CITY OF PORTLAND, OREGON

Staff Presentation to the
Portland Design Commission

Design Advice Request
EA 15-247554 DA
111 NE MLK Jr. Blvd

January 28, 2016

ISSUE #1: Massing

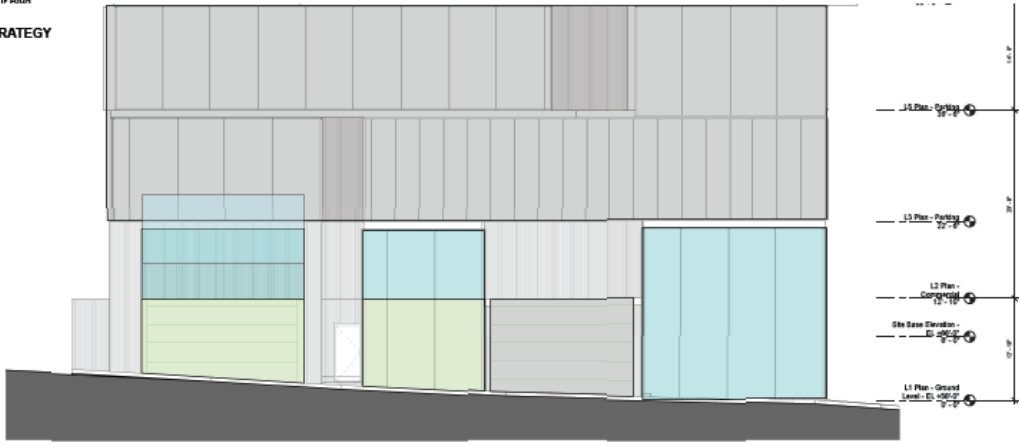
Does the proposed design, a 19-story 8,100 SF floor plate, four-sided façade building, sufficiently integrated to this location?

Given the small footprint of the site and the services necessary to a building of this scale the project is proposing a two story expression at grade. This includes a double height commercial space at the corner for active use. Along the North street frontage a vitrine is proposed for temporary art display and an auto lobby for an automated parking system (example below).

ISSUE #2: Ground Floor
Activation NE Davis St.
Potential Mod. to GFW

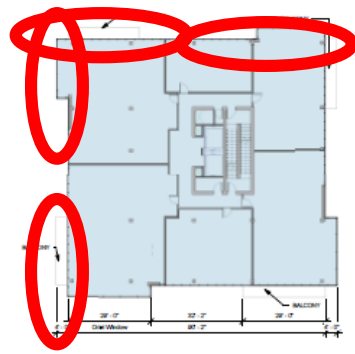
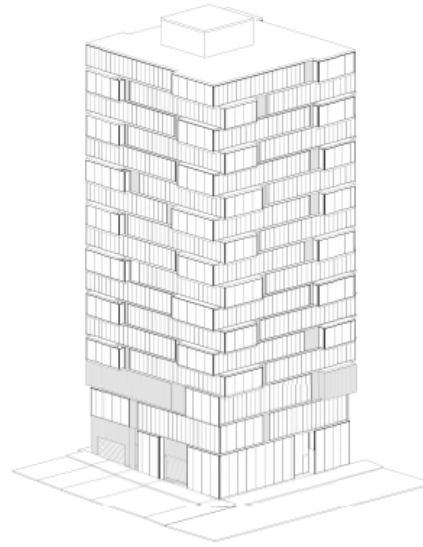
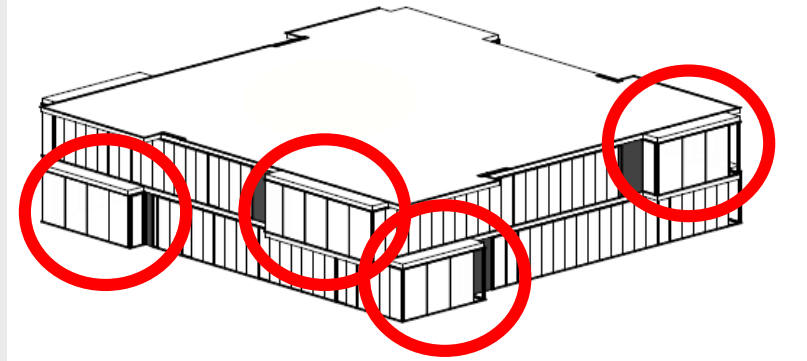
Ground Floor Windows requirement [33.140.230 50% wall length / 25% wall area] does not appear met.

The proposal also introduces two new 20-foot wide curb cuts:

- 1) for mechanical parking access and queuing, and
- 2) for double-wide loading stalls.

ISSUE #4: Materials

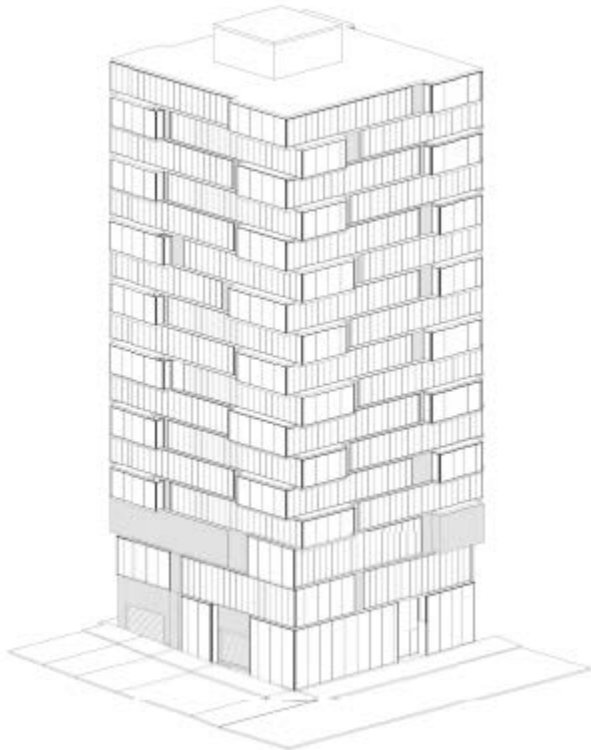
The proposal is for a primary glass curtain wall system. Additional discussion for design of three garage doors.
